# USB Type-C ENGINEERING CHANGE NOTICE

## Title: Right-Angle Plug Dimensional and Test Requirements Applied to: USB Type-C Specification Release 2.3, October 2023

Add mechanical details for right angle USB Type-C plugs to Interface Definition section 3.2.1. Add testing details for right angle plugs to wrenching strength test section 3.8.1.7.

**Figure 3-4 Right Angle USB Type-C Plug(s) Dimensional Requirements**

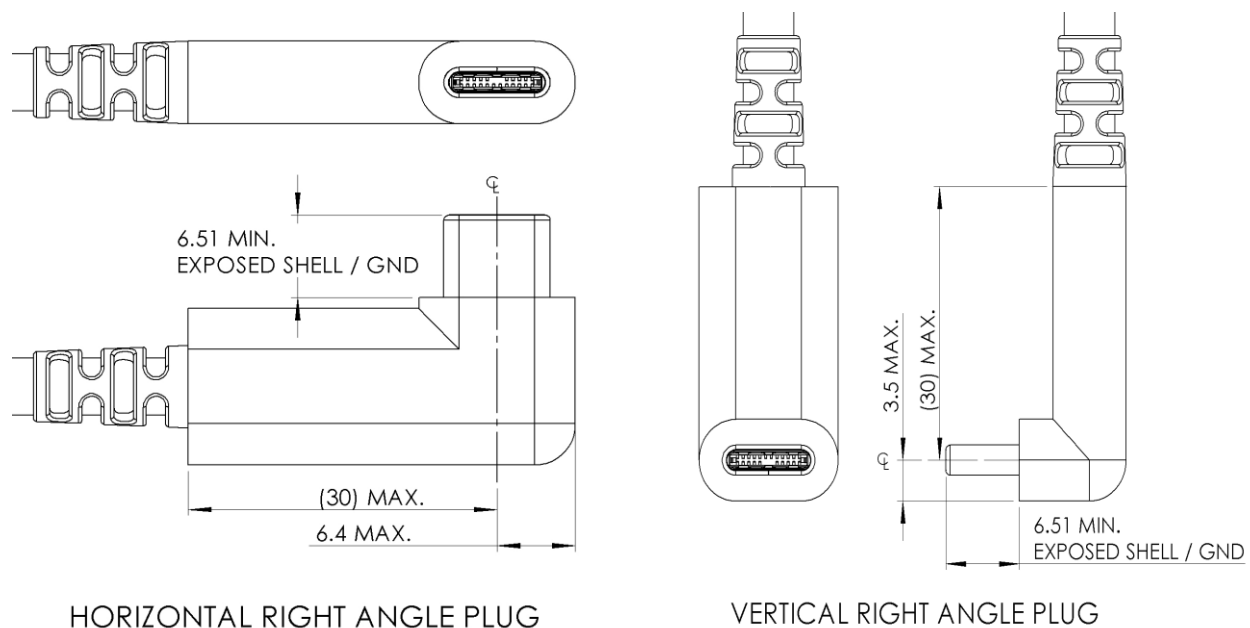
## Add item to Section 3.2.1 Interface Definition

18. USB Type-C Plugs with right angle overmolds shall comply with the dimensions in Figure 3.4.

## Insert new figures to Section 3.2.1 Interface Definition

**Figure 3-7X Torque Force Application Distance for Right Angle Plugs**

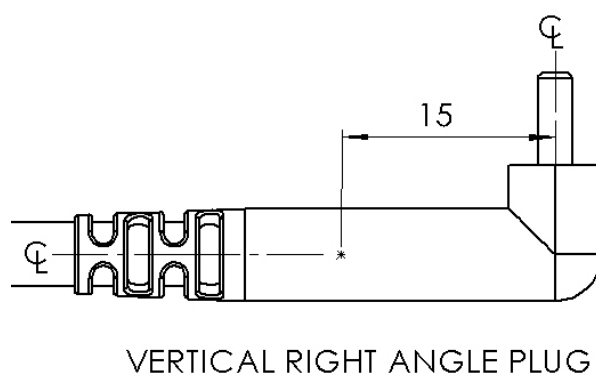
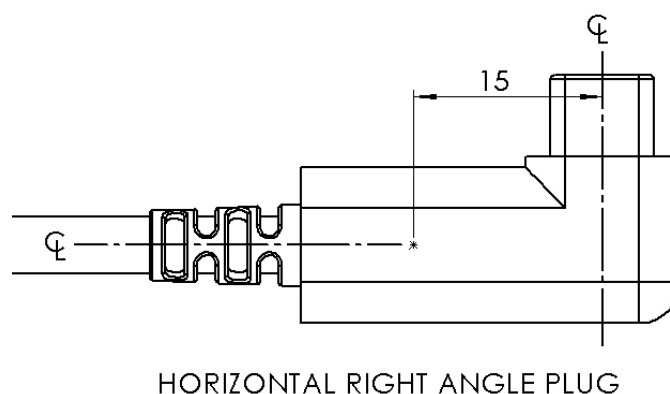
## Wrenching Strength, Section 3.8.1.7, Page 134 & 135

- A moment of 0-0.75 Nm (e.g., 50 N at 15 mm from the edge of the receptacle) is applied to a plug inserted in the test fixture in each of the four directions. A single plug shall be used for this test...

- A moment of 0-0.75 Nm (e.g., 50 N at 15 mm from the edge of the receptacle) is applied to a plug inserted in the test fixture in each of the four directions. USB Type-C Plugs with right angle overmolds shall apply torque forces of 50 N, 15mm from the centerline of the plug perpendicular to the direction of the cable exit, along the centerline of the cable, (see Figure 3-7X). This force will be applied in all four directions for Horizontal right angle plugs and in three direction for Vertical right angle plugs, (force in opposition to the insertion direction causes Vertical right angle plugs to disconnect from the test fixture). If a suitable surface for applying the force is not available, the force will be scaled to provide the equivalent force at the plug interface or the overmold shall use a clamp fixture to provide a suitable surface for applying the torque and moment forces. A single plug shall be used for this test....

- Note that in order to test horizontal right angle plugs, a receptacle fixture with a vertically mounted receptacle may be required to access the inside surface of the overmold for applying the test force.
